GNRO-2011/00104

SUBJECT: Request for Additional Information Regarding
Criticality Safety Analysis

Grand Gulf Nuclear Station, Unit 1
Docket No. 50-416
License No. NPF-29

Attachment 1
GNRO-2011/00104
Grand Gulf Nuclear Station
Criticality Safety Analysis
Responses to Requests for Additional Information
Chemical Engineering Branch

Figure 1: Racklife Predicted and Measured SFP Silica

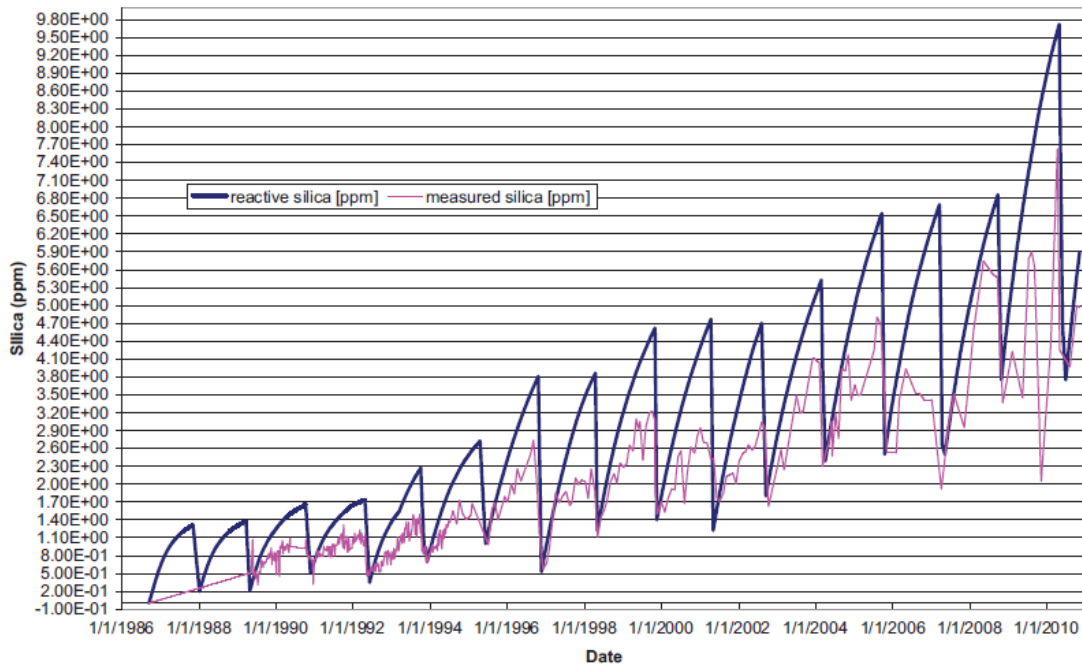
In the GGNS response letter dated May 3, 2011, it states that RACKLIFE analysis will be performed each cycle. Please discuss and justify why performing RACKLIFE once a cycle, instead of increasing the frequency, is acceptable for determining Boraflex degradation.

Updating the Racklife model once each cycle is sufficient as the Boraflex degradation is a slowly varying, longer-term effect. Table 1 provides the maximum boron loss for various time periods over the lifetime of the racks.

The slowly increasing trend shown above is also reflected in the silica levels measured in the spent fuel pool (SFP) shown in Figure 1. Figure 1 presents the Racklife predicted silica levels (i.e., reactive silica), which are significantly higher than those actually being measured in the pool. Note that the rapid drops in silica levels correspond to a dilution of the pool water that occurs during refueling outages. The silica predictions reflect the conservative assumptions in the Racklife evaluation and demonstrate the ability of the Racklife analysis to account for and conservatively model the increasing loss rate.

While the loss rate is increasing over time as expected, it is still relatively low at less than 1% per year. This is not significant compared to the margin between the current condition and condition assumed in the CSA under review. Thus, performing Racklife evaluations once per cycle is acceptable.

Figure 2: Comparison of Rack/Badger Difference to a Normal Cumulative Distribution

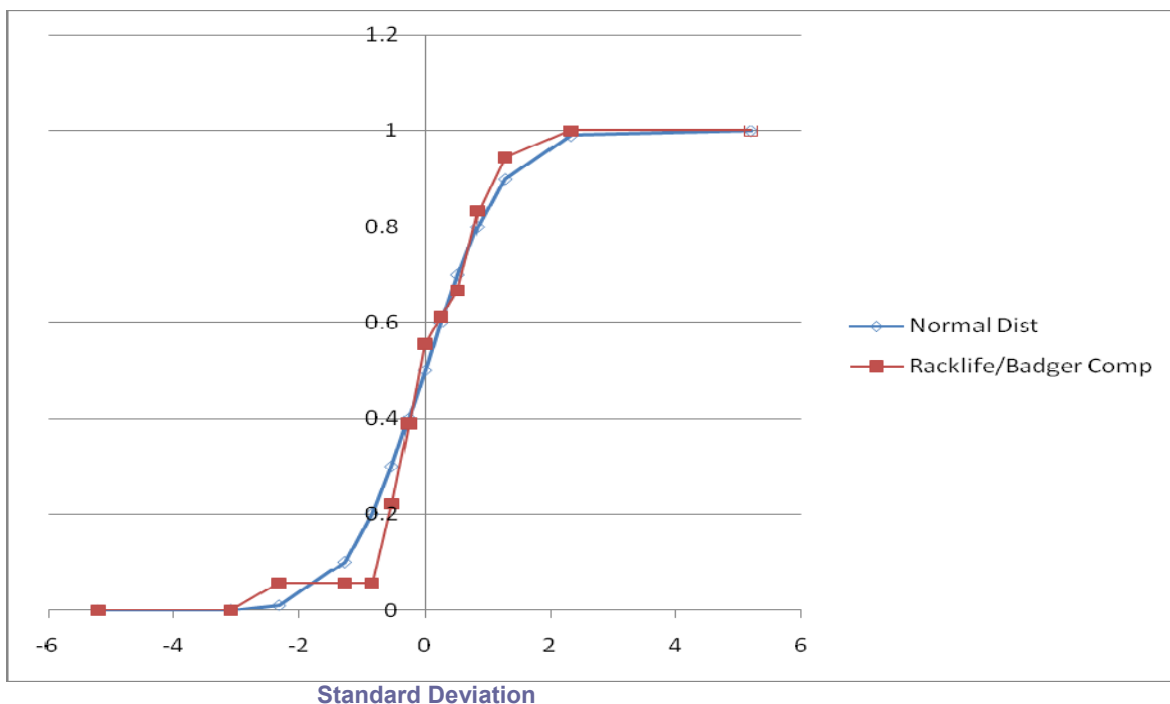
In the GGNS response letter dated April 21, 2011, in the response to RAI 34, it states that the difference in the distributions between the BADGER and RACKLIFE areal density results is based on a visual comparison to the normal cumulative probability distribution. Please discuss how this visual comparison is conducted and discuss how it is statistically significant.

The visual comparison to the normal cumulative probability distribution was a tool used in conjunction with the Shapiro-Wilk test to show that the difference in the distributions between the BADGER and RACKLIFE areal density results were essentially a normal distribution and could statistically be treated as such. Figure 2 shows the cumulative distribution for both the BADGER/RACKLIFE comparison results and a normal distribution. The x-axis is the number of standard deviations about the mean and the y-axis is the cumulative probability.
